Product Change Notification

Product Change Notification: E-18-007949

PCN Date: 14-JUN-18

DEUTSCH Brand Size 20 Stamped and Formed Gold Contacts.

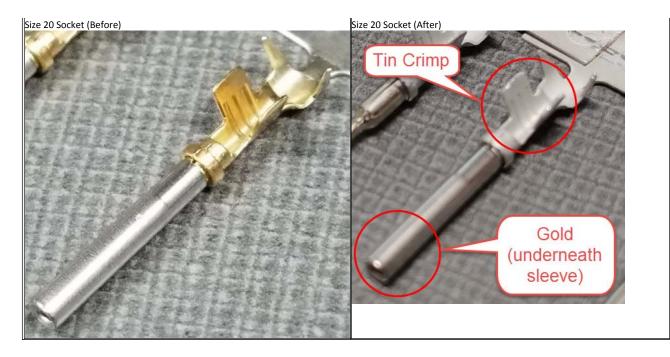
Dear Customer, in an effort to continuously improve our products, TE-ICT will update the gold region for the Size 20 stamped and formed Pins and Sockets. The thin gold flash layer will no longer extend into the crimp area, but the thick gold layer will remain in the Pin/Socket interface area. Tin will be added to the crimp area. This will not impact connector performance. IMPORTANT: This is a continual change so the current and previous revisions of this part can be used interchangeably in the field. This change is being phased in gradually and previous revisions may remain stocked until use.

Reason for Changes:				
Manufacturing / Process Requirements. Standardization of the plating coverage compared to AMPSEAL size 16 Stamped and Formed contacts.				
Estimated Dates:				
Last Order Date (Obsolete Parts Only):	First Date To Ship (Changed Parts Only):			
	15-SEP-2018			
Last Ship Date (Obsolete Parts Only):	Last Date for Mixed Shipments: (Changed Parts Only):			
	23-DEC-2023
